SEWAGE DISPOSAL TESTING

MARYLAND STATE DEPARTMENT OF HEALTH

SUBDIVISION Braeburn LOT NO. 27, Plat 1

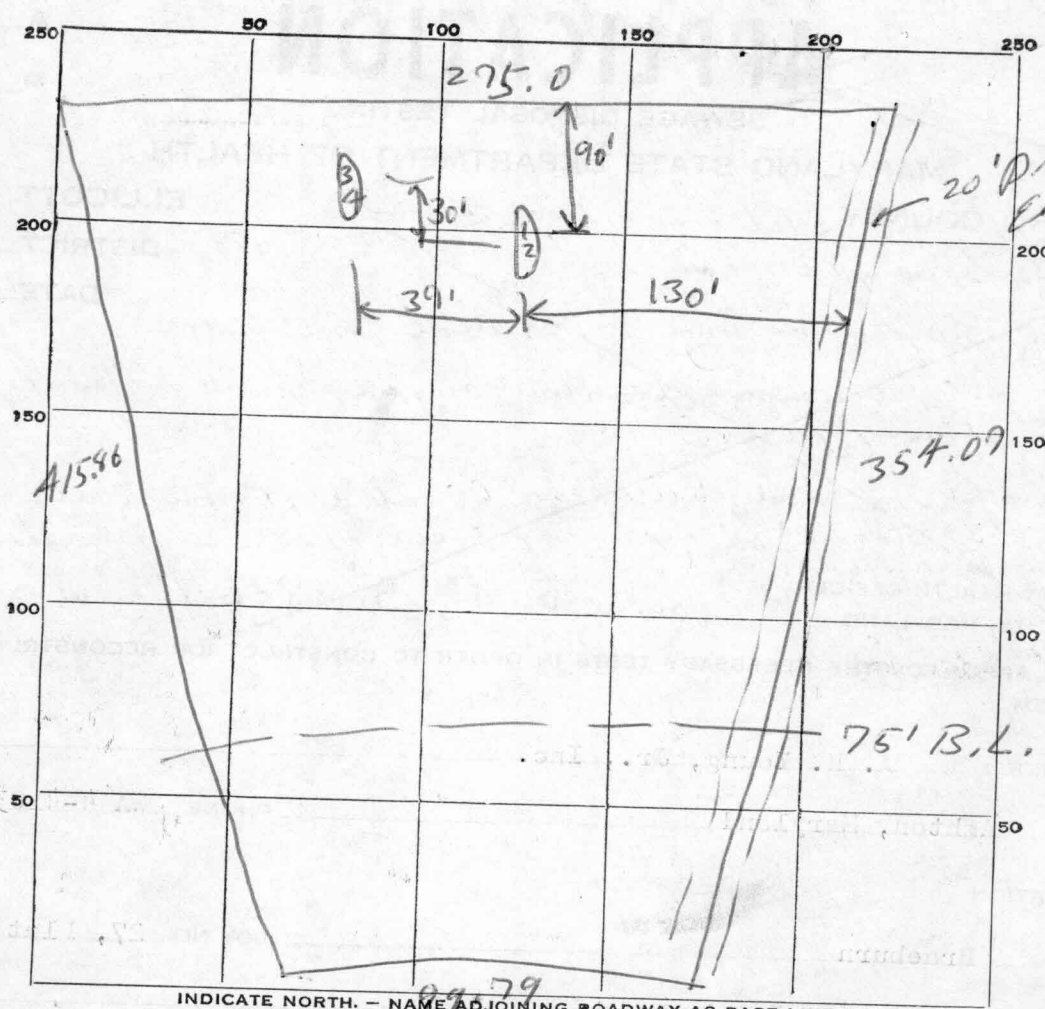
REJECTED BY WZFP FOR ANY - WATER IN PERC AREA DATE 1973
(KIND OF SYSTEM)

REASONS FOR REJECTION OR HOLDING WATER AT 5' IN LOW PART OF PERC AREA

IN 1973 RE-TEST SHORTLY AFTER HURRICANE AGNES - APPROX WITHDRAWN

8/6/73 PER WILLIAM ZEPP // LOT MUST BE RETESTED IN WET SEASON. C. Williams
8/28/85

Leaching Bed 30 ft long and 20 ft wide installed at a depth not exceeding 5 ft below original grade. This depth is measured to bottom of gravel.

Place Leaching Bed between 60 and 90 ft from rear lot line and between 130 and 170 ft from right sideline as seen when facing lot from Braeburn Rd.
